Authors have now well-taken into account most comments from my first and second reviews.

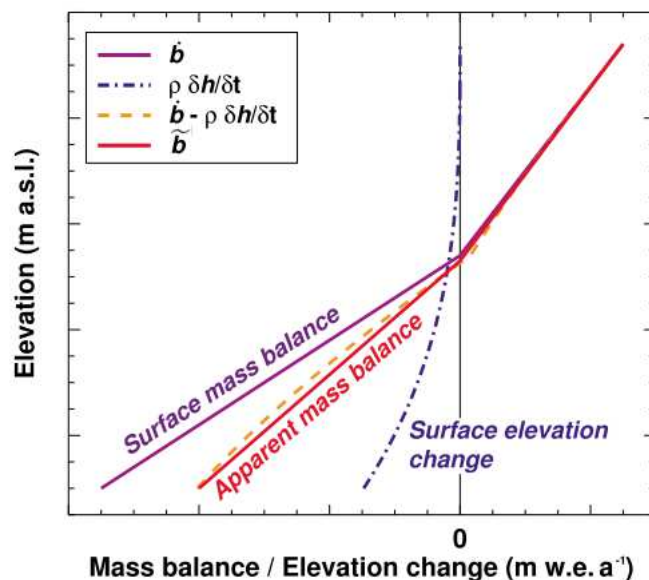
I still fully disagree with the statement that the ELA corresponds to 0 elevation change. This is not a key point/finding of this paper but it is not glaciologically acceptable. The publications by Huss & Farinotti (cited by the authors to back up their assumption) do not agree with this statement. I reproduce below the Figure 1 of their 2012 JGR paper. Dh/dt does not cross the axis! I recommend that the authors use the much more conventional hypothesis that the ELA = median altitude of the glacier (see for example <http://www.the-cryosphere.net/9/2135/2015/> or Figure 3 in <https://www-cambridge-org.biblioplanets.gate.inist.fr/core/services/aop-cambridge-core/content/view/7A6999E78A3C73FDF340119462BFF313/S0260305500000239a.pdf/div-class-title-the-high-mountain-asia-glacier-contribution-to-sea-level-rise-from-2000-to-2050-div.pdf>).

In the event where the authors would decide to keep this wrong statement in their paper (I really hope not and do not see what they would stick to it), authors need to explain how they tackle the glaciers for which the dh/dt curves do not cross the 0 elevation change line (this is the case for some of the glaciers in Figure 5 and will be observed for many glaciers in a retreat state due to simple principles of glacier dynamics). More specifically, how do the authors quantitatively define the "altitude where the curve closes 0"? It is a bit too vague for a scientific paper and lack reproducibility. Do they use a specific minimum absolute value for dh/dt to define where dh/dt become undistinguishable from 0 based on the uncertainty of their measurements?
